Central Valley Regional Water Quality Control Board  
18 October 2024 Board Meeting

Response to Comments  
for  
City of Yuba City, Wastewater Treatment Facility  
Tentative Waste Discharge Requirements

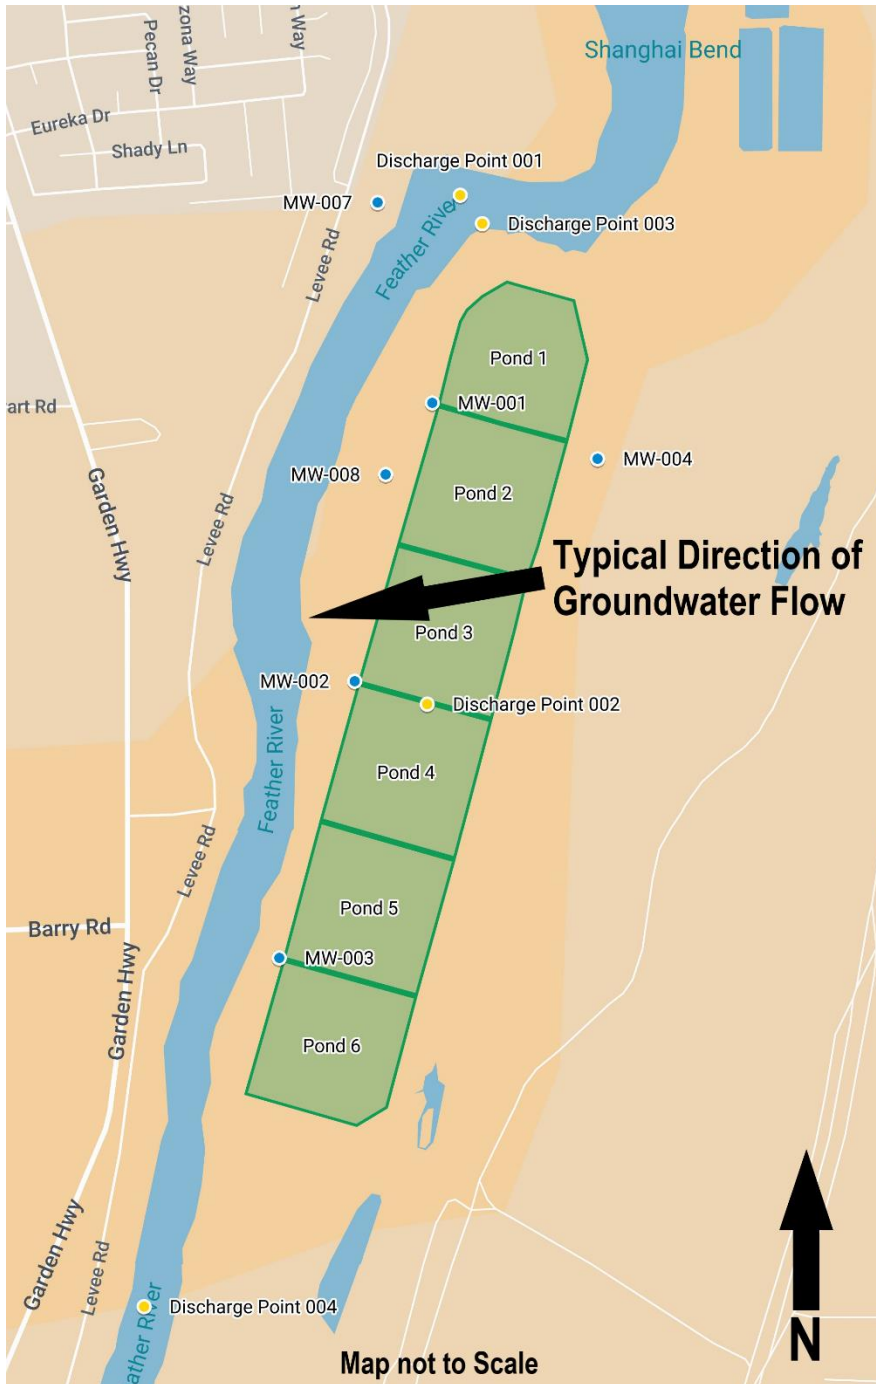
Ms. Kipps requests revision of Figure B-2 in Attachment B, *Detailed Map*, to include a north arrow, a scale (or indicate "not to scale"), and an arrow depicting groundwater flow direction in the disposal ponds vicinity indicating groundwater flow direction is typically towards the river.

**RESPONSE:** Staff concur and have updated Figure B-2 to include a north arrow, a note to indicate the figure is "not to scale", and an arrow depicting groundwater flow direction in the disposal ponds vicinity indicating groundwater flow direction as shown below:
